## COMMISSION IMPLEMENTING REGULATION (EU) 2018/502

of 28 February 2018

**amending Implementing Regulation (EU) 2016/799 laying down the requirements for the construction, testing, installation, operation and repair of tachographs and their components****(Text with EEA relevance)**

Figure 1

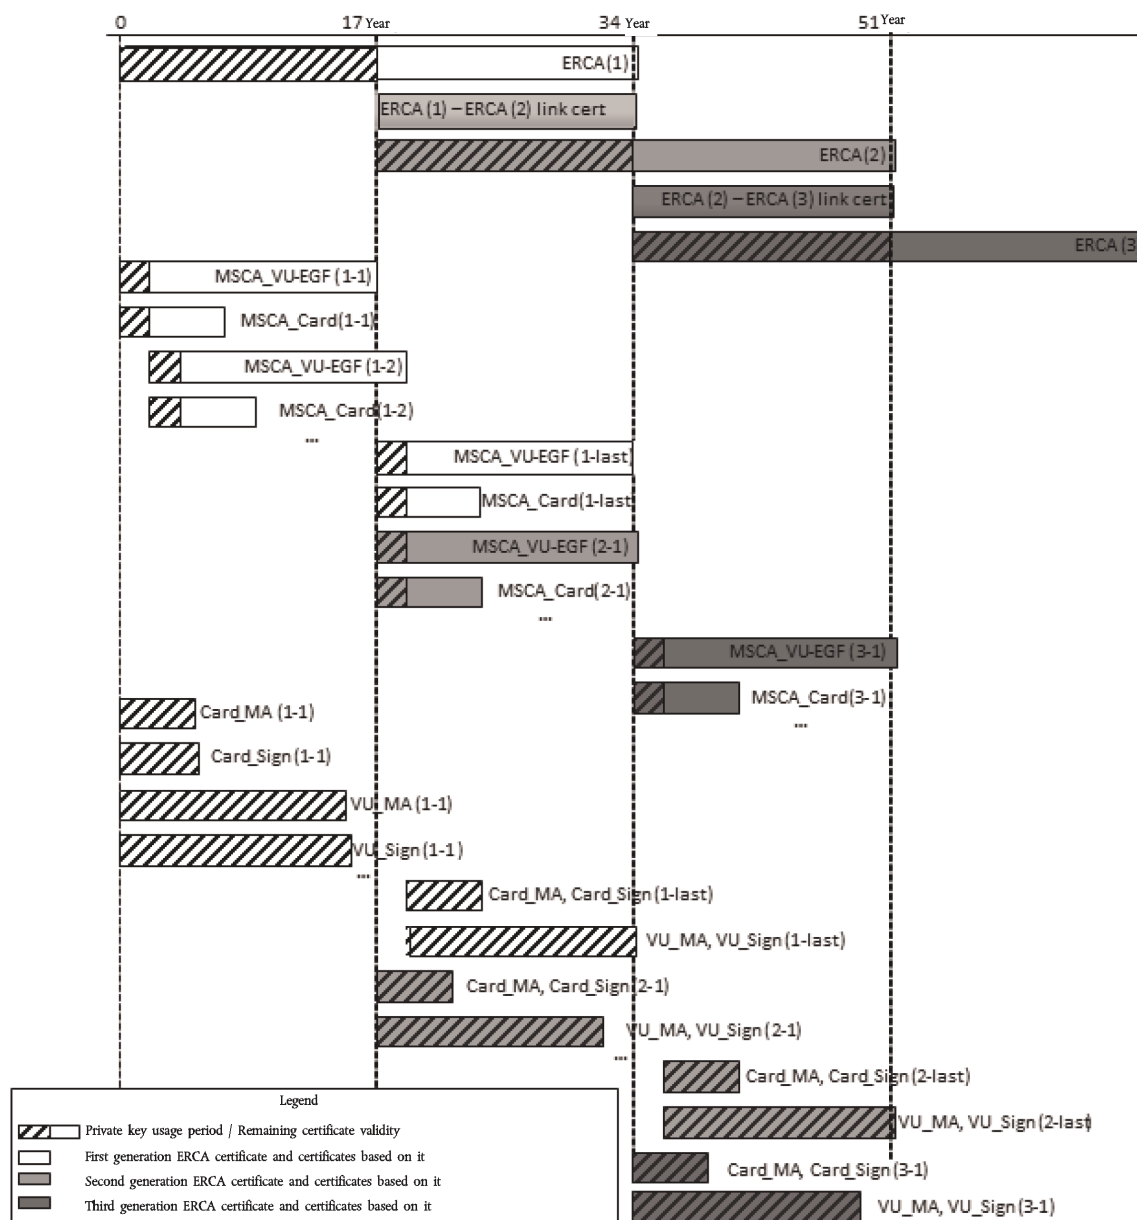
(i) Figure 1 is replaced by the following:

**Issuance and usage of different generations of ERCA root certificates, ERCA link certificates, MSCA certificates and equipment certificates**

Figure 6

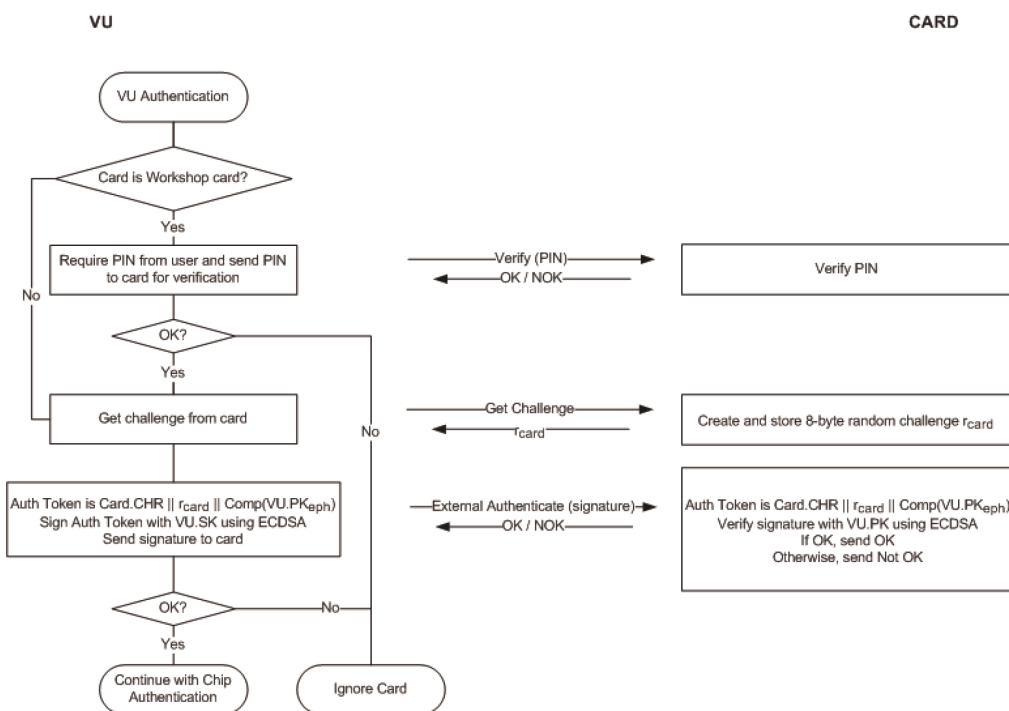
(ii) in paragraph CSM\_171, Figure 6 is replaced by the following:

Figure 13

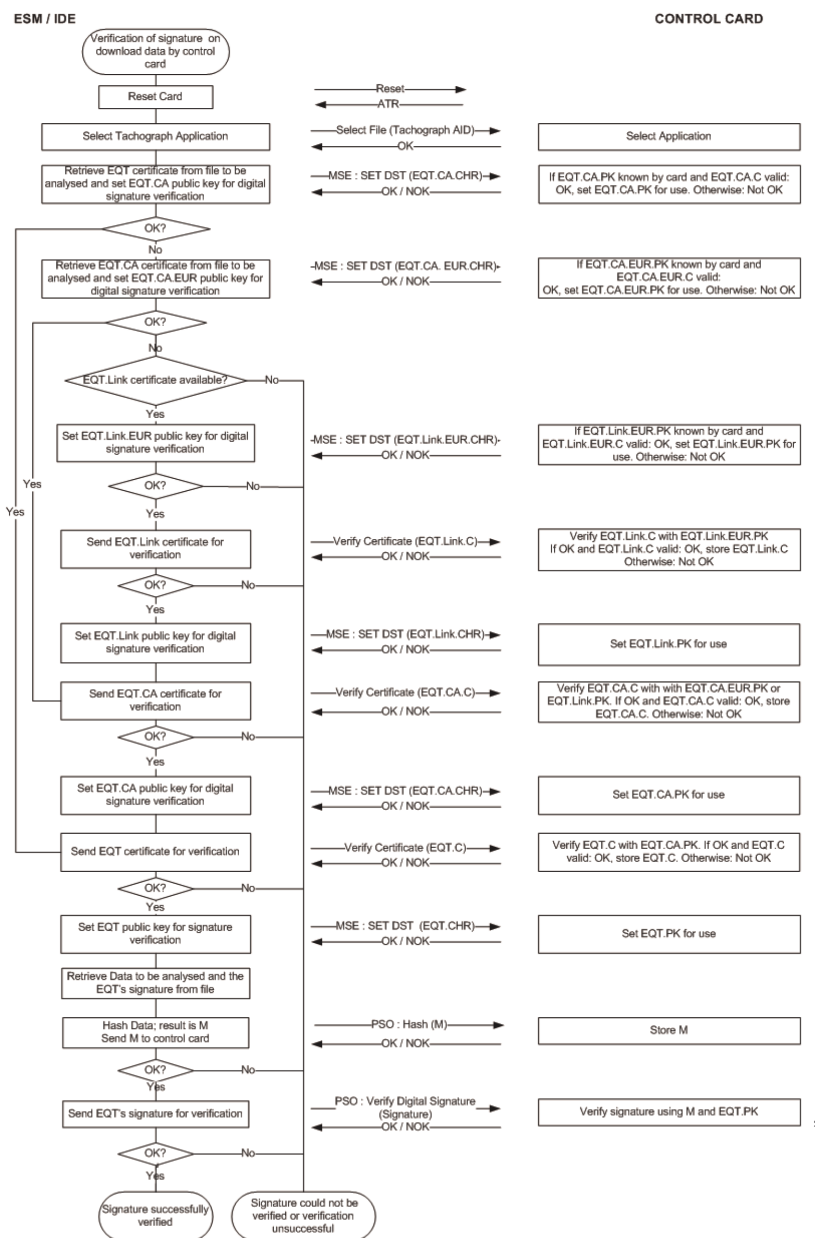
(ii) Figure 13 is replaced by the following:
